FUTURE MELBOURNE (PLANNING) COMMITTEE REPORT

APPLICATION FOR PLANNING PERMIT : TP-2012-617 261-275 ABBOTSFORD STREET AND 135-139 ARDEN STREET, NORTH MELBOURNE

DELEGATED PLANNING APPLICATION REPORT

Application number: TP-2012-617

SHADOW DIAGRAMS

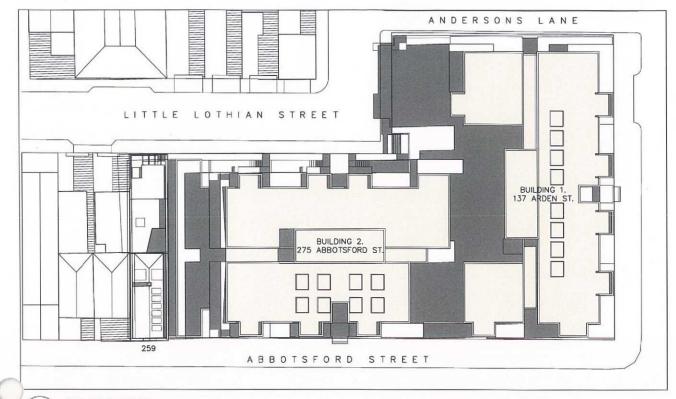
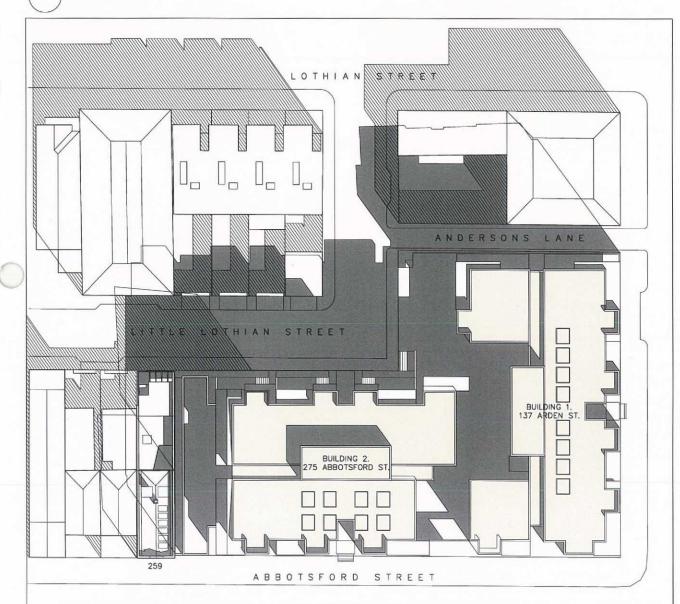
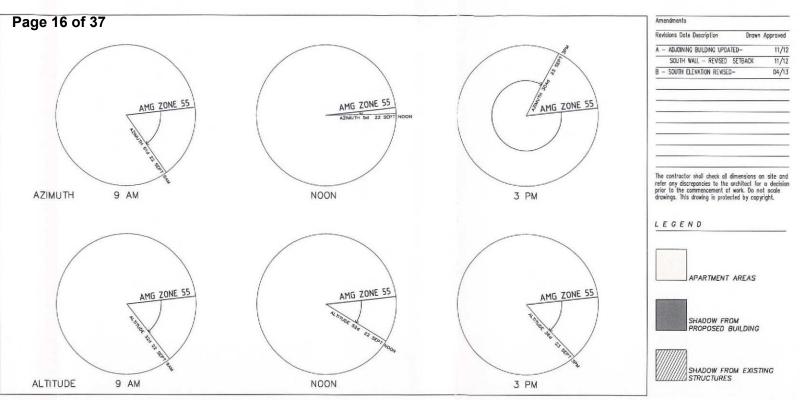
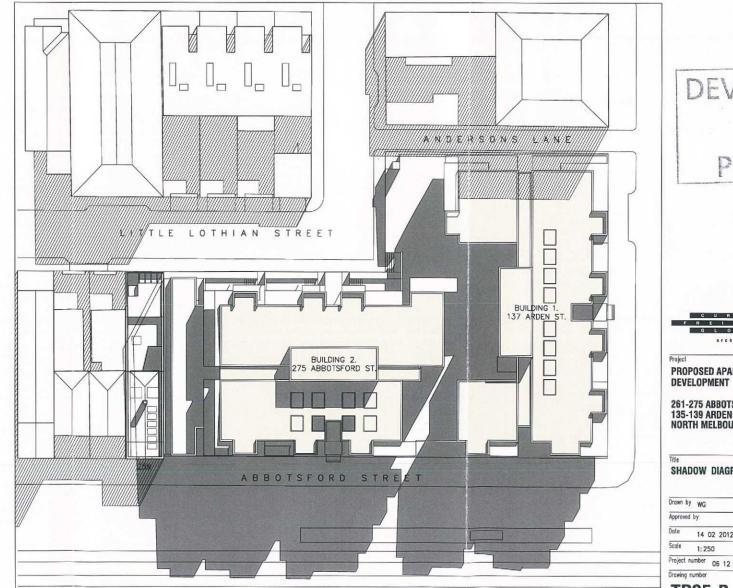
In terms of overshadowing, the applicant has submitted amended plans which redesign the proposal so it has no impact on the objector's solar features between 9am and 3pm at the equinox (22 September).

It is considered fortunate that the applicant is willing to modify their development in order to provide unfettered access to sunlight to objector's solar features between 9am and 3pm at the equinox (22 September) when clearly this goes further than guidance from VCAT on what might be 'reasonable' in the circumstances.
